PROPOSAL REQUEST

PROJECT:
Union Center Rural Facility
19625 Ball Field Rd.
Union Center, SD 57787

PROPOSAL REQUEST NO.: 04
DATE OF ISSUANCE: April 5, 2019

Description: Item 1: Owner requested additional data outlets in Multi-purpose classroom 109

SD-2 SCALE: 1/8" = 1'-0"

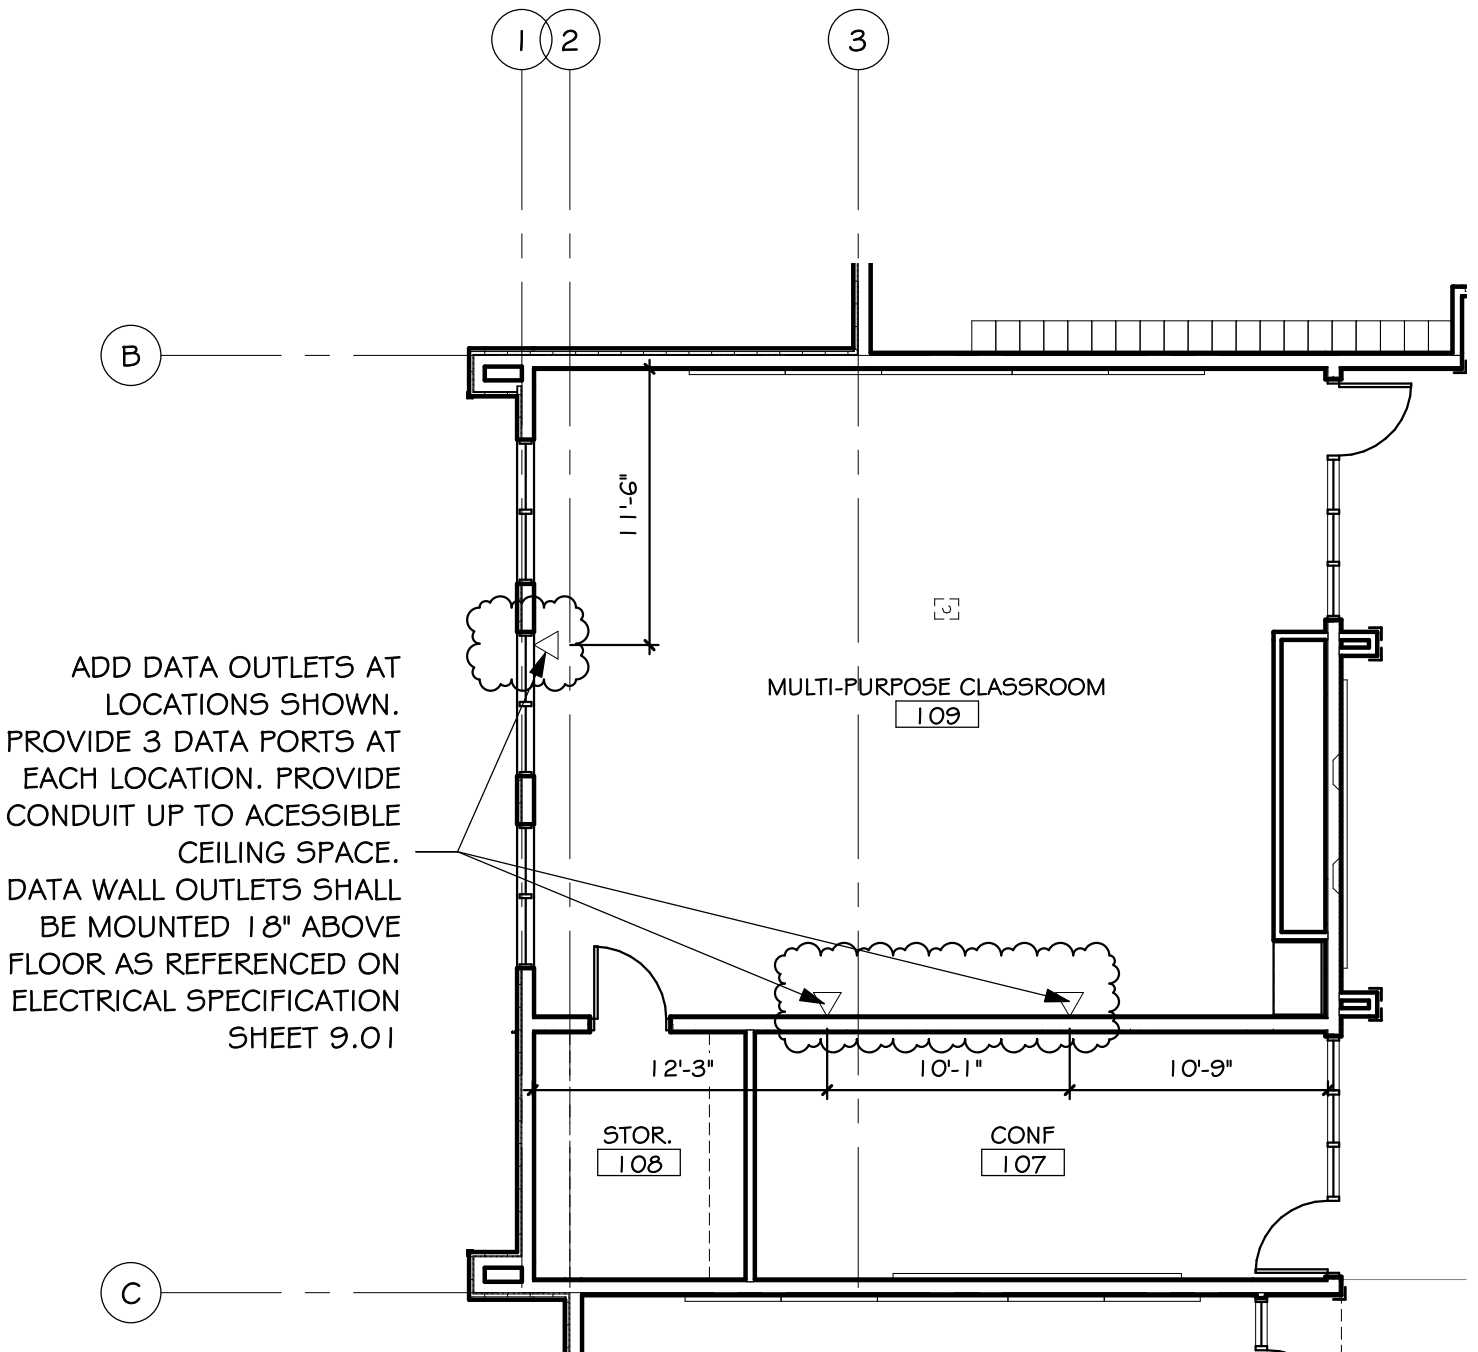
- 1) Add owner requested data outlets in multi-purpose classroom at locations shown on attached Supplemental Drawing SD-2, dated 04-05-2019.
 - a) Add data outlets. Provide 3 data ports at each location shown on SD-2
 - b) Provide ¾" conduit stub to an accessible ceiling space at each new data outlet location.
 - c) Provide required data cat6 cabling at each port. Fully terminate and test per specification requirements on sheet 9.01 Electrical Specifications
